MIL-G-50680C (AR)
AMENDMENT 2
9 September 1992
SUPERSEDING
AMENDMENT 1
24 June 1991

MILITARY SPECIFICATION

GATE CIRCUIT, MULTIPLE BOARD ASSEMBLY - UPPER: 9342753

FIGURE 5. Board assembly, upper test setup.

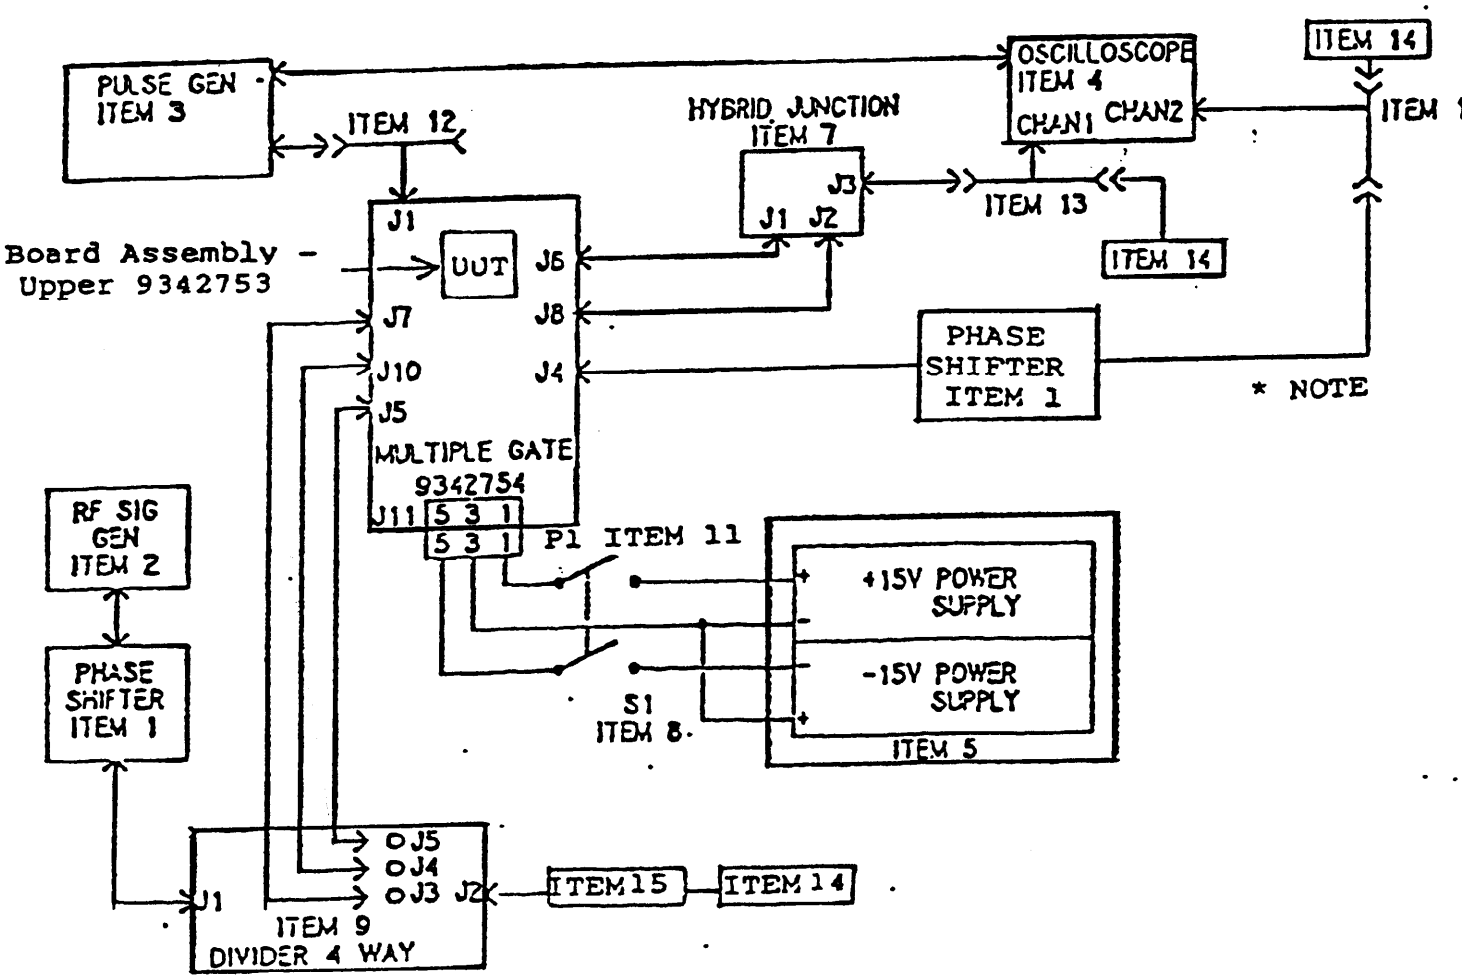
Add new Figure 5 as included (page 6A).

*NOTE: Adjust Channel 2 Cable length as necessary to place Channel 1/Channel 2 Waveform relationship into phase shifter adjustment range.

"3.5.2.3.4 Gate noise. With the board assembly-upper connected with the test setup as shown in Figure 5, a 60 ± 1% MHz signal and a monitored 2.8 V p-p signal per gate applied to J5, J7 and J10 of the unit under test, the amplitude of the algebraic sum of the Early Gate and Sum Gate signals during the Early Gate period shall be less than 1.0 V p-p. The amplitude of the algebraic sum of the Late Gate and inverted Sum Gate signals during the Late Gate period shall be less than 1.0 v p-p."

*4.7.3.4.4 Gate noise. Connect the unit under test to the test setup per Figure 5. Adjust channel 2 Phase Shifter so that Early Gate on channel 1 is 180° out of phase with the Sum Gate on channel 2. Adjust variable gain on channel 2 for equal amplitude waveforms on channels 1 and 2. Place oscilloscope in channel 1 and 2 algebraic add function and readjust channel 2 phase shifter for Early Gate null. Resultant waveforms in the Early Gate shall be less than 1.0 V p-p. Place oscilloscope channel 2 in invert mode. Readjust amplitude and phase for Late Gate null. Resultant waveforms in the Late Gate shall be less than 1.0 V p-p."
